Interactive comment on “Will UK peatland restoration reduce dissolved organic matter concentrations in upland drinking water supplies?” by Jennifer Williamson et al.

Jennifer Williamson et al.

Interactive comment on Hydrol. Earth Syst. Sci. Discuss., <https://doi.org/10.5194/hess-2020-450>, 2020.

Fig. 1.

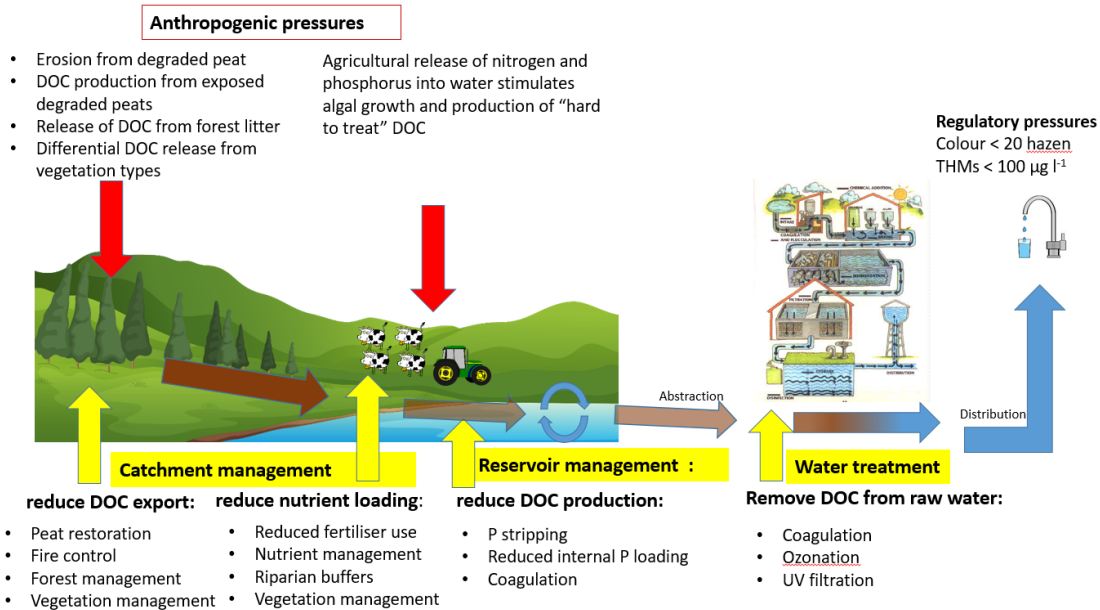
1.7. The paper would, however, benefit hugely from a conceptual figure that could illustrate the mechanisms that control DOM concentrations and quality, including those related to catchment restoration. This figure could then be used to guide the structure of the revised paper. We have attached a potential conceptual diagram to this response. This will be further neatened provided it is felt that we have covered the main points. We would put this diagram in the introduction and add the aims up front to aid the reader in following the text through. This would be included with a paragraph as follows before section 1.1: The past decade has seen peatland restoration become an integral part of the UK’s environment policies, including the development of an English Peat Strategy, the Welsh Government’s commitment to the restoration of all semi-natural peatlands and Scotland’s national peatland plan, because of the potential role of restoration in improving biodiversity, carbon storage and natural water management. As nearly three quarters of the storage capacity of drinking water reservoirs in the UK is derived from water draining peaty areas (Xu et al 2018) the UK water industry has investigated whether peatland restoration and management could improve water quality at source in order to reduce treatment costs and risk of regulatory failure (See schematic). This review summarises the available evidence regarding the effects
